**PARK CITY MUNICIPAL CORPORATION
PLANNING DEPARTMENT ADMINISTRATIVE PUBLIC HEARING MINUTES
PLANNING DEPARTMENT CONFERENCE ROOM
MARSAC MUNICIPAL BUILDING
JUNE 5, 2025**

- A. 1328 Park Avenue – Historic District Design Review –** The Applicant Proposes to Modify and Expand a Non-Historic Addition on a Landmark Historic Site in the Historic Residential - Medium Zoning District. PL-24-06312.

1940s tax photo from the Historic Site Inventory Form.

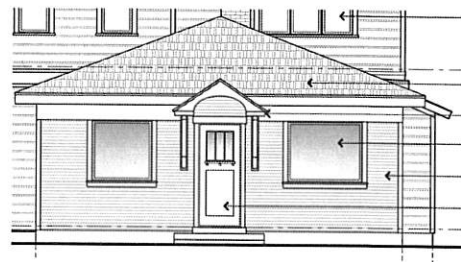
Complies: The Applicant proposes to replace the non-historic front door with a door more reflective of the 1925 era.

Existing south elevation, with the non-historic addition proposed to be removed in orange.

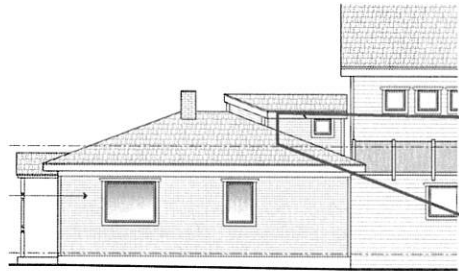
Complies: The proposed modifications will not impact the Landmark Historic Structure’s form or materials. The Applicant proposes adding a partial second level and partial basement level to the existing non-historic addition. The Applicant proposes to remove a non-historic structure on the Historic Structure and to return the roof form to its original shape.

Proposed south elevation, provided by the Applicant.

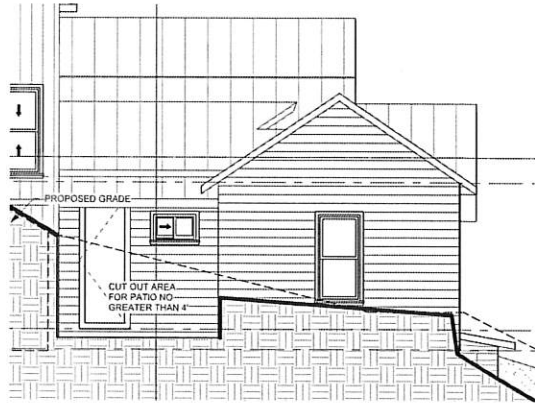
Complies: The Applicant proposes to keep the two main entrance door openings, restore one historic door and replace the other non-historic door. The Applicant proposes to add one door opening where a window opening is on the south, secondary facade.

Interior elevation with measurements by Staff.

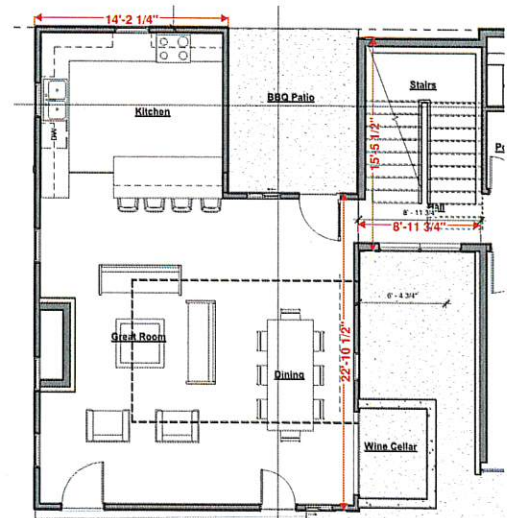
Complies: The proposed addition is more than 50% of the footprint of the Historic Structure. The proposed transitional element width is 15 feet, 4 inches and not more than two-thirds of the 22-foot, 10 inch Historic Structure’s wall it is connected to.
